Subject: License Amendment Request  
Adoption of Emergency Action Level Schemes Pursuant to NEI 99-01,  
Revision 6

Waterford Steam Electric Station, Unit 3  
NRC Docket No. 50-382  
Renewed Facility Operating License No. NPF-38

1. Waterford 3 Steam Electric Station EAL Technical Basis (Markup)
2. Waterford 3 Steam Electric Station EAL Technical Basis (Clean)
3. Waterford 3 Steam Electric Station NEI 99-01 Revision 6 EAL Comparison Matrix
4. Waterford 3 EAL Wallchart (for information only)
5. Supporting Referenced Document Pages

Figure 1: Containment Integrity or Bypass Examples

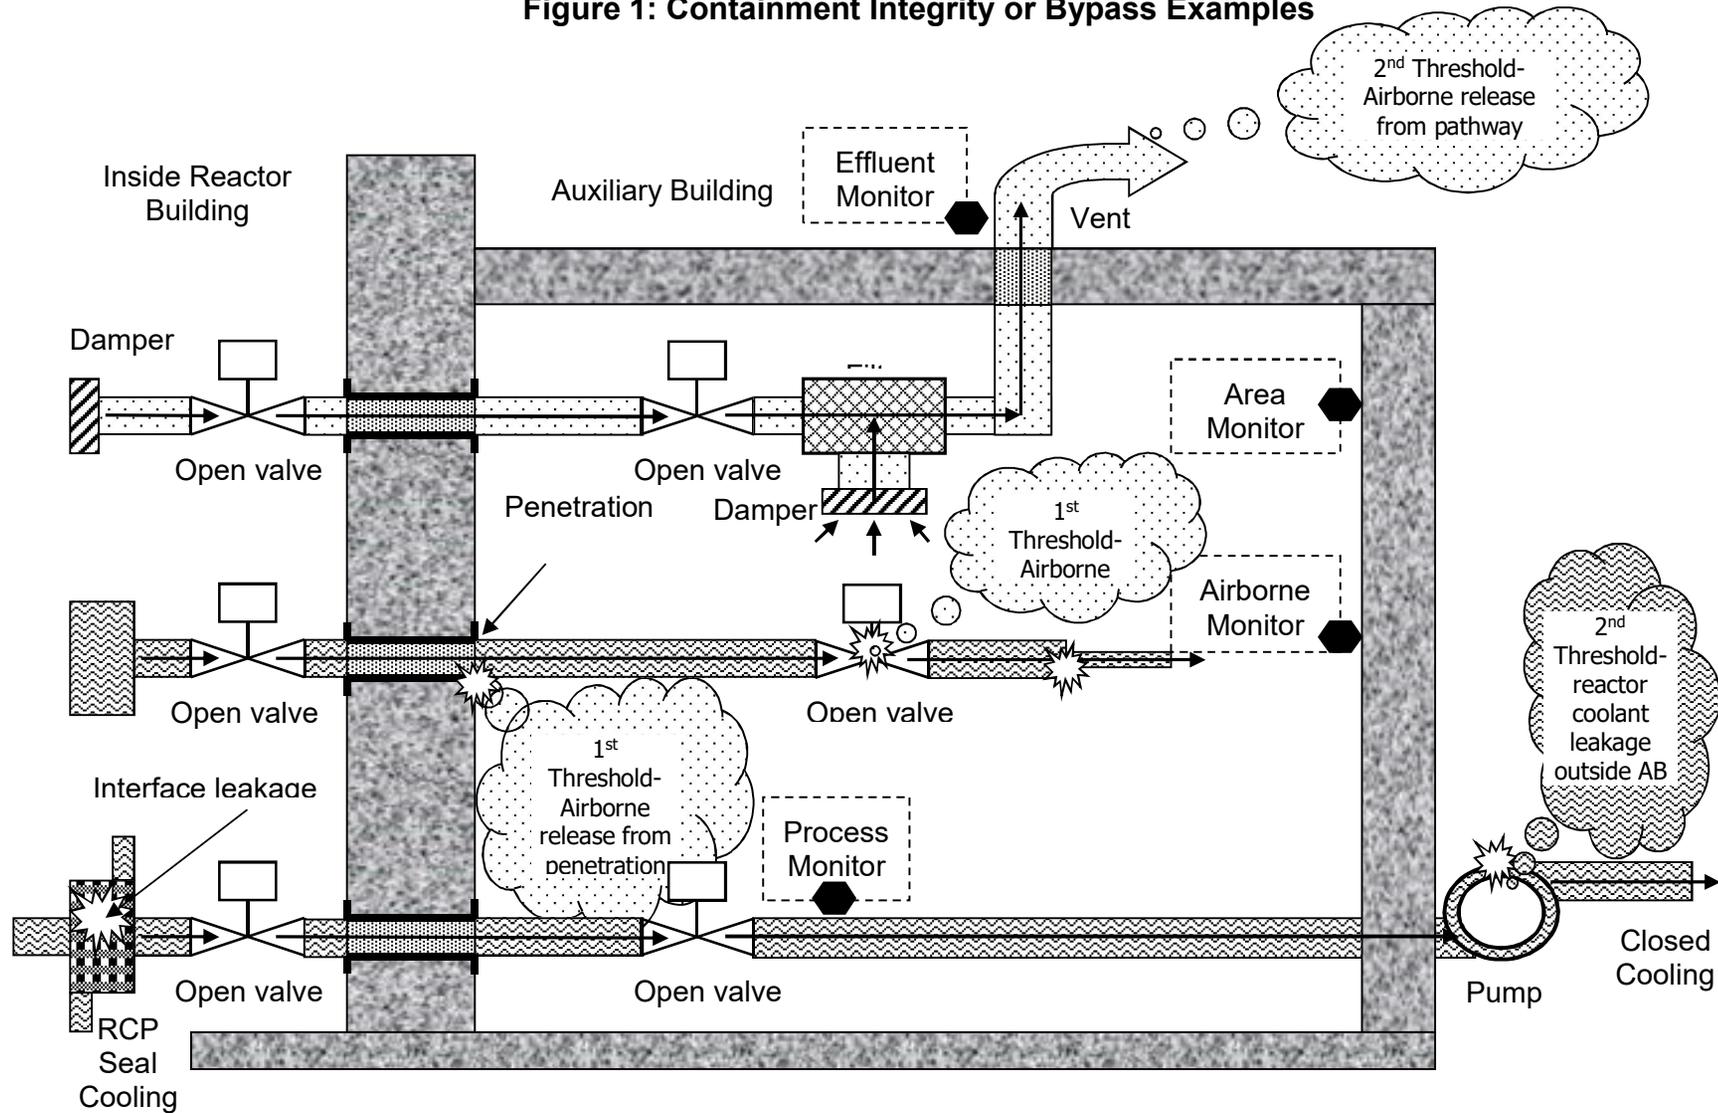
Refer to the middle piping run of Figure 9-F-41. In this simplified example, a leak has occurred at a reducer on a pipe carrying reactor coolant in the Auxiliary Building. Depending upon radiation monitor locations and sensitivities, the leakage could be detected by any of the four monitors depicted in the figure and cause threshold 4.A.1CNB4 to be met as well.

**Figure 1: Containment Integrity or Bypass Examples**

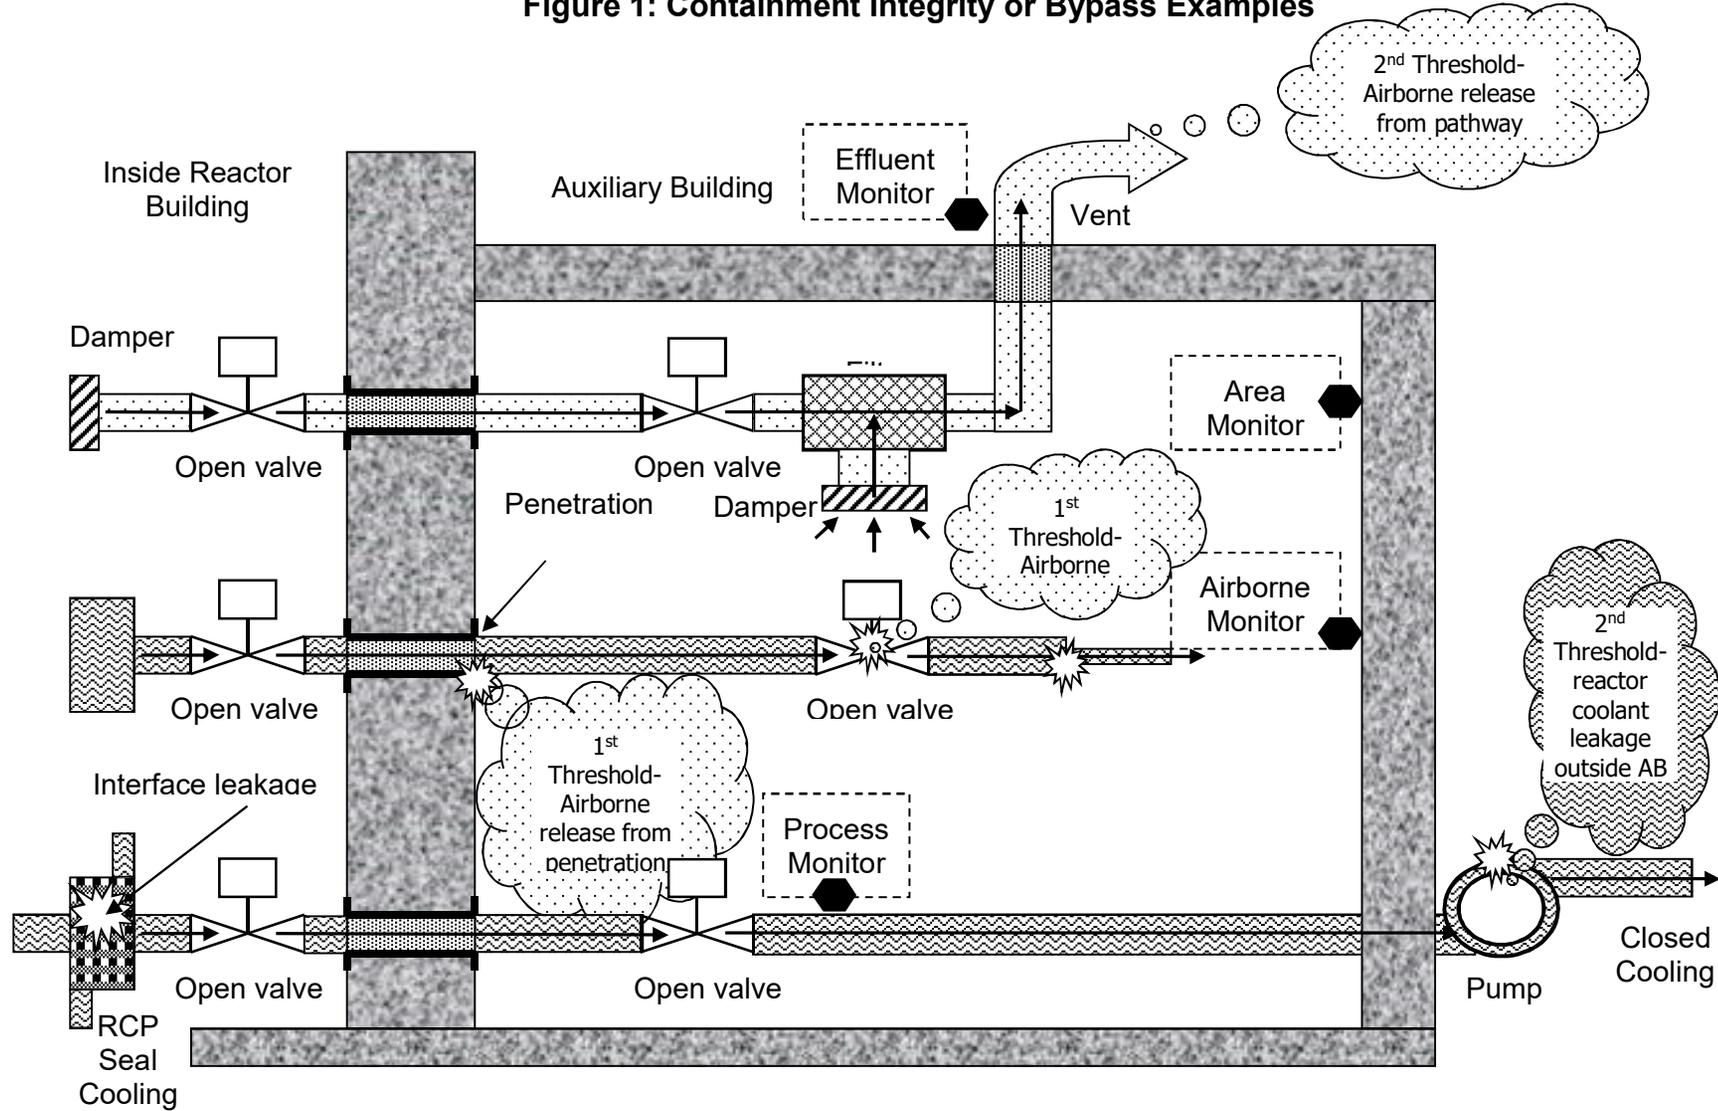
Refer to the middle piping run of Figure 1. Two simplified examples are provided. One is leakage from a penetration and the other is leakage from an in-service system valve.

Refer to the top piping run of Figure 1. In this simplified example, the inboard and outboard isolation valves remained open after a containment isolation was required (i.e., containment isolation was not successful). There is now an UNISOLABLE pathway from the containment to the environment.

Refer to the bottom piping run of Figure 1. In this simplified example, leakage in an RCP seal cooler is allowing radioactive material to enter the Auxiliary Building. The radioactivity would be detected by the Process Monitor. If there is no leakage from the closed water cooling system to the Auxiliary Building, then no threshold has been met. If the pump developed a leak that allowed steam/water to enter the Auxiliary Building, then the second threshold would be met. Depending upon radiation monitor locations and sensitivities, this leakage could be detected by any of the four monitors depicted in the figure and cause the first threshold to be met as well.

Refer to the middle piping run of Figure 1. In this simplified example, a leak has occurred at a reducer on a pipe carrying reactor coolant in the Auxiliary Building. Depending upon radiation monitor locations and sensitivities, the leakage could be detected by any of the four monitors depicted in the figure and cause threshold CNB4 to be met as well.
